Appendix A

Analysis of the Proposed Standards

The following document is a summary of the major substantive changes proposed for the scoping and technical requirements of the 1991 Standards at 28 CFR pt. 36 adopted in 1991, as amended in 1994. The full text of the 2004 ADAAG is available for review on the Access Board's web site, www.access-board.gov, along with a chart that shows the relationship between the 1991 Standards and the 2004 ADAAG.

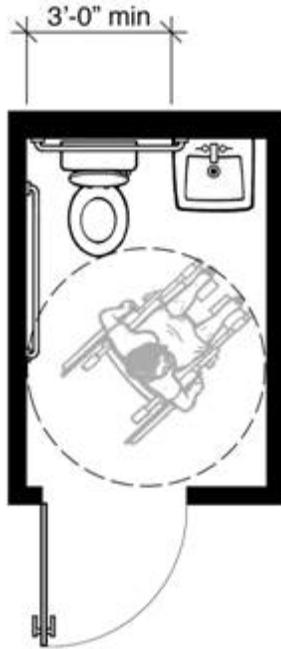
Water Closet Clearance. Proposed section 604.3 represents a change where a lavatory is installed adjacent to the water closet. The 1991 Standards allow lavatories to be placed 18 inches minimum from the water closet centerline, which precludes side transfers. To allow greater transfer options, the proposed standards prohibit lavatories from overlapping the clear floor space at water closets, except in dwelling units.

Commenters urged the Department not to adopt section 604.3 claiming that it will require single-user toilet rooms to be two feet wider than the requirements now provide, and this additional requirement will be difficult to meet.

The requirements at section 604.3.2 specify how required clearance around the water closet can overlap with specific elements and spaces. An exception, that applies only to residential dwelling units, permits a lavatory to be located no closer than 18 inches from the centerline of the water closet. The requirements at section 604.3.2 increase accessibility for individuals with disabilities.

Plan-1A: 1991 Standards Minimum with Out-swinging Door
5'-0" X 7'-3" • 36.25 Square Feet

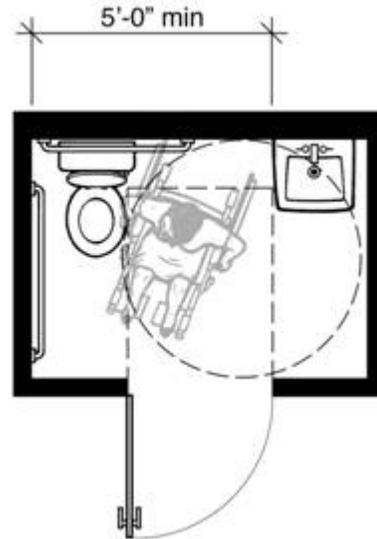
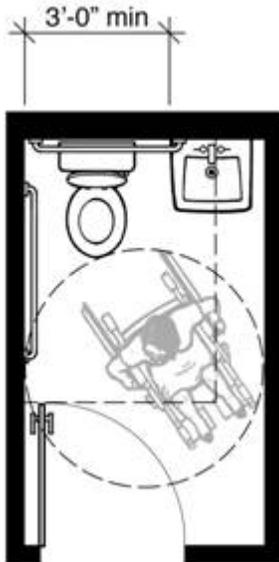
This plan shows a typical example of a single-user toilet room that meets the minimum requirements of the 1991 Standards. The size of this space is determined by the minimum width required for the water closet and lavatory between the side walls, the minimum wheelchair turning space, and the space required for the out-swinging door. A lavatory with knee space can overlap the clear floor space required for the water closet provided that at least 36 inches of clearance is maintained between the side wall next to the water closet and the lavatory, see, 1991 Standards 4.17.3 and Fig. 28. A wheelchair turning space meeting section 4.2.3 of the 1991 Standards must be provided. The size of this room requires that the entry door swing out. The room would be larger if the door was in-swinging.

This plan shows a typical example of a single-user toilet room that meets the minimum requirements of the 2004 ADAAG. Features include: five foot minimum width between the side wall of the water closet and the lavatory; 60 inch minimum circular wheelchair turning space; and 36 inch by 48 inch clear maneuvering space for the out-swinging entry door. The 2004 ADAAG requires a floor clearance at a water closet that is a minimum of 60 inches wide by 56 inches deep regardless of approach, section 604.3.1. Except in residential dwelling units, no other plumbing fixtures can be located in this clear space, section 604.3.2. The 2004 ADAAG, at section 304.3, allows the turning space to extend into toe and knee space provided beneath fixtures and other elements, section 304.3. Required maneuvering space for the entry door (inside the room) must be clear of all fixtures. If the door had both a closer and latch then additional space would be required to the latch side, section 404.2.4.1 and Figure 404.2.1 (c). This layout is three point five percent (3.5%) smaller than the accompanying Plan-1A: 1991 Standards Minimum with Out-swinging Door example.

Plan-2A: 1991 Standards Minimum with In-swinging Door
 5'-0" X 8'-6" • 42.50 Square Feet

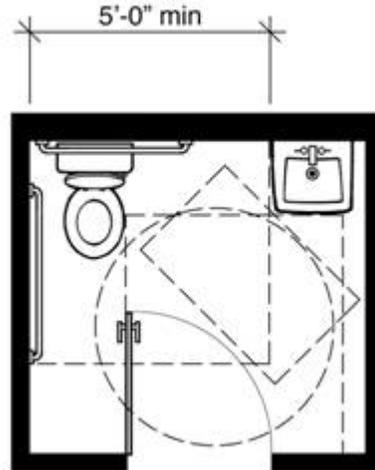
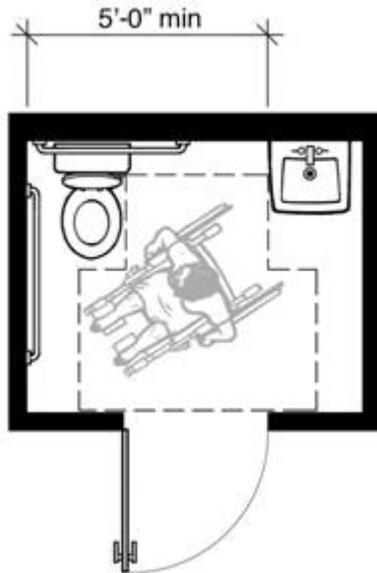
This plan shows a typical example of a single-user toilet room that meets the minimum requirements of the 1991 Standards. Depending on the width of the hallway and other circulation issues, it can be preferable to swing the entry door into the toilet room. Businesses and public entities typically prefer to have an in-swinging door. The in-swinging door increases overall room size because it cannot swing over the required clear floor space at any accessible fixture, 1991 Standards 4.22.2. This increases the room depth from Plan-1A. The door is permitted to swing over the required turning space shown as a 60 inch circle.

This plan shows a typical example of a single-user toilet room that meets the minimum requirements of the 2004 ADAAG when the entry door swings into the room. In the proposed standards an exception allows the entry door to swing over the clear floor spaces and clearances required at the fixtures if a clear floor space complying with section 305.3 (30 inches by 48 inches) is provided outside the arc of the door swing, section 603.3.3 exception 2. The required maneuvering space for the door, section 404.2.4.1 and figure 404.2.4.1(a), also is a factor in room size. This clear space cannot be obstructed by the plumbing fixtures. Note that this layout provides more space for turning when the door is closed than Plan-1B.

This layout is seven percent (7%) larger than the accompanying Plan-2A: 1991 Standards Minimum with in-swinging Door example.

**Plan-3: Meets Both 1991 Standards
2004 ADAAG**

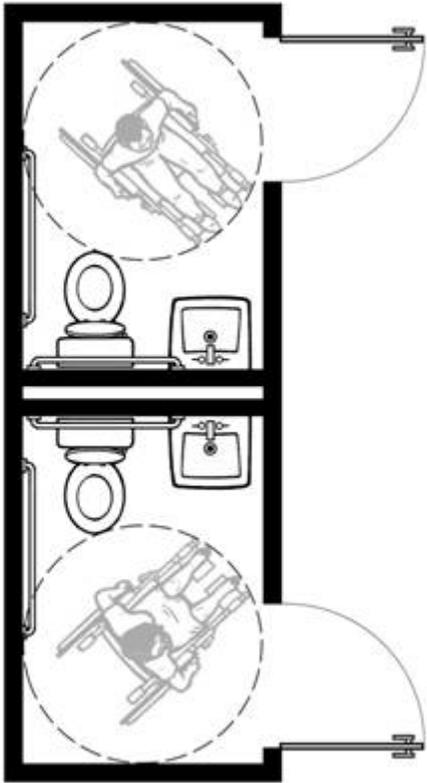
This plan shows an example of a single-user toilet room that meets the minimum requirements of both the 1991 Standards and 2004 ADAAG. A T-shaped turning space has been used, 1991 Standards Figure 3(a) and 2004 ADAAG Figure 304.3.2, to maintain a compact room size. An out-swinging door also minimizes the overall layout depth and cannot swing over the required clear floor space or clearance at any accessible plumbing fixture.

This layout is eleven percent (11%) larger than the Plan-1A: 1991 Standards Minimum with out-swinging Door example shown at the beginning of these plan comparisons.

**Comparison of Minimum Size Single-user Toilet Room “Pairs”
With Fixtures Side-by-Side**

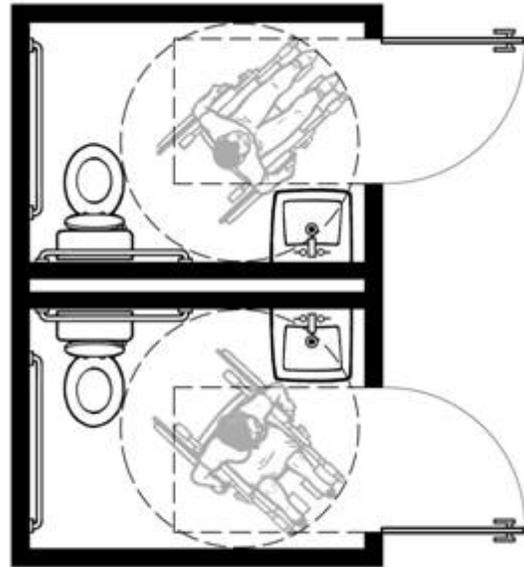
Above are a men's/women's room configuration comparison for Plans 1A and 1B.

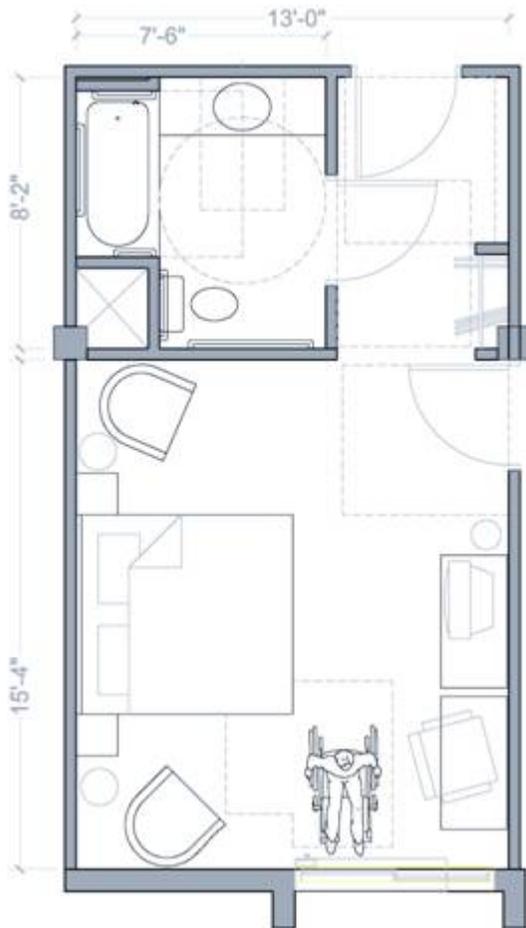
Vanity Counter Space. Proposed section 806.2.4.1 provides that if vanity counter top space is provided in nonaccessible transient lodging guest toilet or bathing rooms, comparable vanity space must be provided in accessible hotel guest toilet or bathing rooms.

A commenter questioned whether in existing facilities vanity countertop space may be provided through the addition of a shelf. In some circumstances, the addition of a shelf in an existing facility may be a reasonable way to provide access. However, this is a determination that must be made on a case-by-case basis.

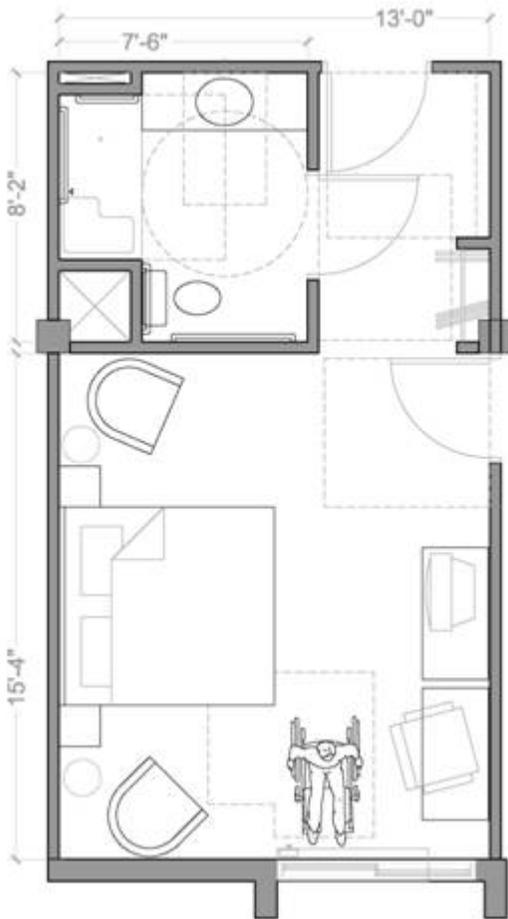
The drawing demonstrates that an accessible 13 foot wide hotel room based on 2004 ADAAG does not decrease the size of the room from the 1991 Standards.

This bathroom has a “comparable vanity counter top space.” § 806.2.4.1. The bathtub is recessed, so the water closet's rear grab bar is reduced to “24 inches long . . . centered on the water closet . . . due to the location of a recessed fixture adjacent to the water closet.” § 604.5.2 Exception 1. A “turning space . . . shall be provided within the room,” § 603.2.1, where “required clear floor spaces, clearance at fixtures, and turning space shall be permitted to overlap,” § 603.2.2. This “60 inches diameter” turning space is “permitted to include knee and toe clearance.” § 304.3.1.
